RIGON	Technical Bulletin			No. RTB-006
SUBJECT: Ink Cartridge Seal				DATE: Nov.30 1990 PAGE: 1 of 1
PREPARED BY: S.Asai CHECKED BY:		FROM: Copier	Technic	cal Support Section
CLASSIFICATION: Action Required Troubleshooting Retrofit Information	☐ Revision of s ☐ Information of the control of th		Ges 5	EL: 5/955 5230/5270 160/1170

RIGOH	Technical	Bulletin		No. RTB-007
SUBJECT: Drum Retrofit to prev	vent Ink Leakage	(Refer to M/B No	. 21)	DATE: Jan.31.1991 PAGE: 1 of 3
PREPARED BY: S.Asai CHECKED BY:		FROM: Copier	Technic	cal Support Section
CLASSIFICATION: Action Required Troubleshooting Retrofit Information	Revision of s	service manual only	Ges !	EL: 5/955 5230/5270 1160/1170

RIGON	Technical	Bulletin		No. RTB-008
SUBJECT: Thermal Head Clean	er Cap			DATE: Jan.31th '91 PAGE: 1 of 2
PREPARED BY: S.Asai CHECKED BY:		FROM: Copier	Technic	cal Support Section
CLASSIFICATION: Action Required Troubleshooting Retrofit Information	Revision of sometion of the control	service manual only	Ges 5	EL: 35/955 5230/5270 160/1170

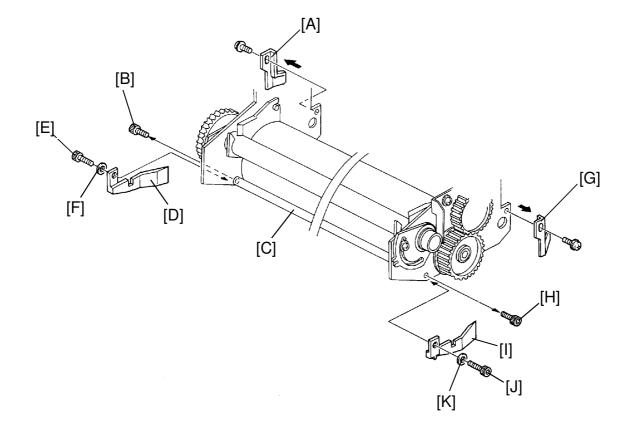
4. Remove the old front drum blade (C2004745) [A] (1 screw).
 5. Remove the internal hexagon head screw (M4 x 6) [B] securing the ink roller shaft stay [C], then install the new front drum blade (C2074745) [D] and secure it with the internal hexagon head screw (M4 x 8) [E] and the flat washer [F].

6. Remove the old rear drum blade (C2004746) [G] (1 screw).

7. Remove the internal hexagon head screw (M4 x 6) [H] securing the ink roller shaft stay [C], then install the new rear drum blade (C2074746) [1] and secure it with the internal hexagon head screw (M4 x 8) [J] and the flat washer [K].

Note: Do not re-use the old front and rear drum blades.

Adjustment Procedure:

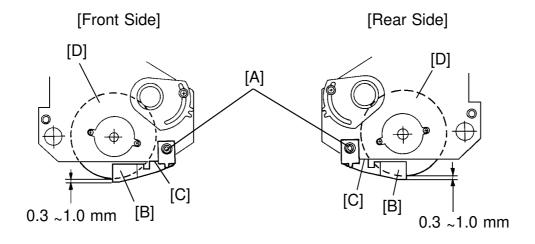
1. Tighten each (front and rear) internal hexagon head screw [A] so that the drum blade [B] contacts the lower edge [C] of the side plate.

Note 1: Make sure that the clearance between the ink roller [D] and the drum blade [B] is 0.3 to 1.0 mm.

Note 2: Make sure that the drum blade edge [E] contacts the ink roller [F].

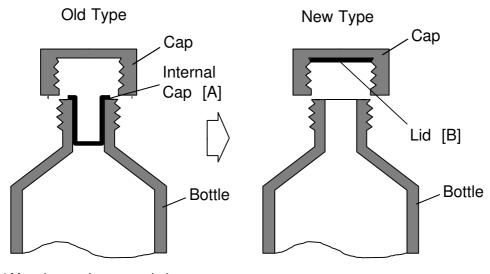
There has been a problem with the internal cap [A] getting stuck inside the thermal head cleaner bottle and it is difficult to pull it out. The internal cap has been changed to a lid [B] as illustrated below:

This modification has been implemented since the November '90 production run. Please note that the part number of the thermal head cleaner remains the same.

[Countermeasure]:

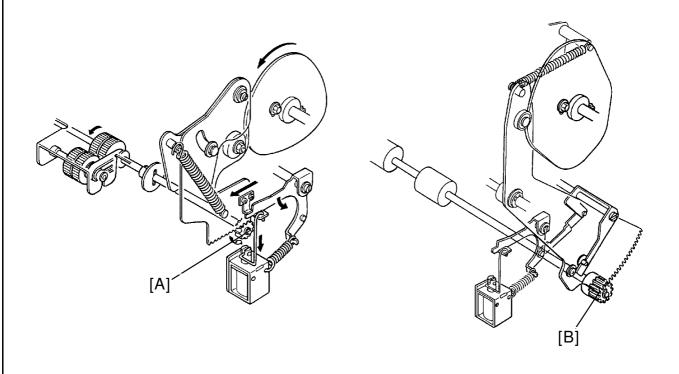
The one-way clutches inside the paper feed and second feed roller gears have worn the roller shafts smooth. The clutch slips and paper jams or is not fed. This tends to occur during high speed printing and is more likely to occur on machines that exceed the recommended monthly copy volume. When the feed mechanism is manually operated to check the paper feed, paper feeds correctly.

- 1. Remove the paper feed roller gear [A] and the second feed roller gear [B].
- 2. With fine sandpaper, lightly sand the roller shaft surface at the point where it comes into contact with the one-way clutch. This increases the coefficient of friction.
- 3. If paper jams continue to occur, replace the one- way clutch.
- 4. If paper jams continue to occur, replace the roller shaft together with the one-way clutch.

[Countermeasure]:

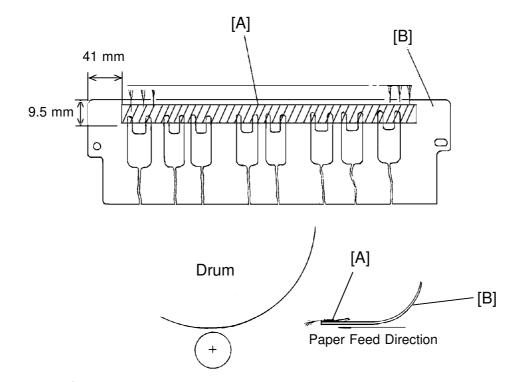
Paper jamming occurs around the drum because of static electricity when the machine is used under low humidity conditions. Heavy static charges will build up around the master during the printing run. This happens particularly when thin paper is being used at high speed rotations. This also happens if the original (and therefore the master on the drum) is changed.

Stick the antistatic brush (P/N: C2079010) [A] on the upper second feed roller guide plate [B] as illustrated below: (The antistatic brush has been registered as a spare part.)

2. INSTALLATION PROCEDURE

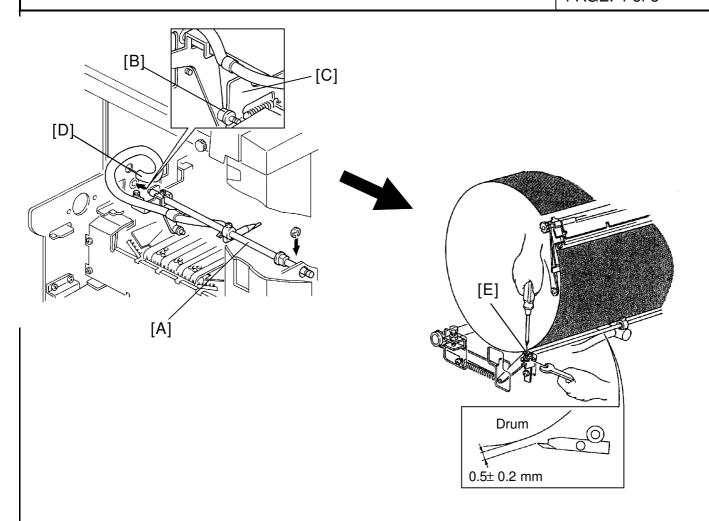
- 1. Open the master eject unit and remove the exit pawl assembly [A] (1 E-ring [B] and 1 spring [C]) from the machine .
- 2. Remove the bushing [D] and the exit pawl lever [E] (1 Allen screw) from the shaft.
- 3. Mount the above exit pawl lever on the new exit pawl shaft [F] (1 Allen screw used on the previous shaft) and insert the bushing onto the shaft.

- EXIT PAWL CLEARANCE ADJUSTMENT -

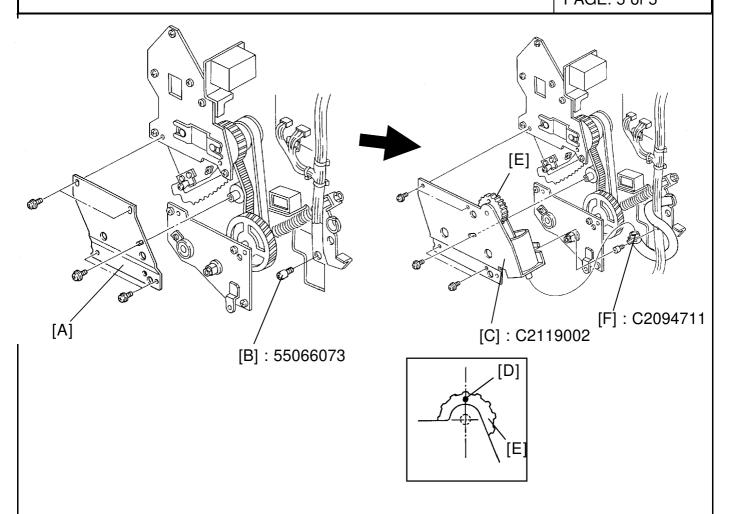
- 6. Manually turn on the paper feed and printing pressure solenoids. Using a spanner (10 mm), gradually rotate the drum rotation shaft counterclockwise to move the exit pawl to the drum.
- 7. When the printing pressure is applied, adjust the clearance between the drum and the exit pawl by turning the screw [E]so that it is 0.5 ± 0.2 mm.

Note: Make sure that the exit pawl does not contact the drum surface and the master clamper several times when the printing pressure is applied.
